UNITED STATES PATENT AND TRADEMARK OFFICE

Office Action Summary

10/782,735

DETAILED ACTION

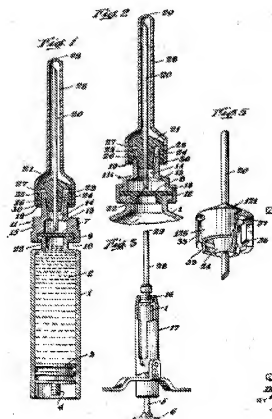
The **Ashkenaz** patent discloses a fixing device for injection needles for pushing onto a thread of an injection apparatus, wherein said fixing device is formed as a cap comprising an open end and a closed end which holds a needle perpendicularly in the middle of the fixing device, and a surface area of the fixing device is slightly spring-elastic in its circumference and comprises at least three cams directed to said thread, said cams perpendicularly engaging with flights of the thread when said cap is pushed onto the thread, wherein each cam comprises at least one notch arranged parallel to the surface circumference.

In relation to **claims 2 and 18**, Ashkenaz shows in figure 5 a cap wherein each cam has two tips, one tip below number 26 and the other tip below number 27. In relation to **claims 3, 16, 17, and 19**, figure 5 shows cams having three points of contact wherein the points of contact can be in different planes. Notably, when a needle is introduced into the vial, the cams that are mounted in skirts (125) will move laterally into different planes. In relation to **claim 4**, figure 5 shows the distance between the tips is

approximately equal to the height of the flight. In relation to **claim 5**, figure 5 shows three skirts (125) acting as springs. In relation to **claim 12**, figures 1, 2, and 5 show an injection apparatus comprising a storage container wherein a needle penetrates into the storage container when the cap is pushed onto the thread of the injection apparatus.

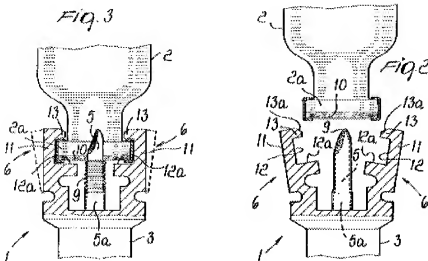
In figures 2 and 3 above, the Azzolini patent shows an infusion system having two spring elements.

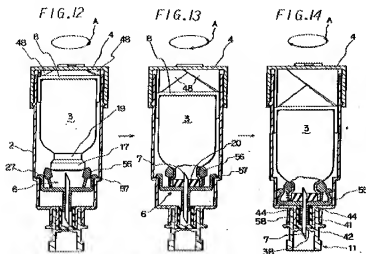
Furthermore, the Uchida patent, in figures 6 and 7 above, shows a design having four spring elements. Accordingly, based on the evidence provided above, factually it can be concluded that spring elements are well known in the art and can be duplicated in various infusion system designs. Therefore, whether the infusion system is designed
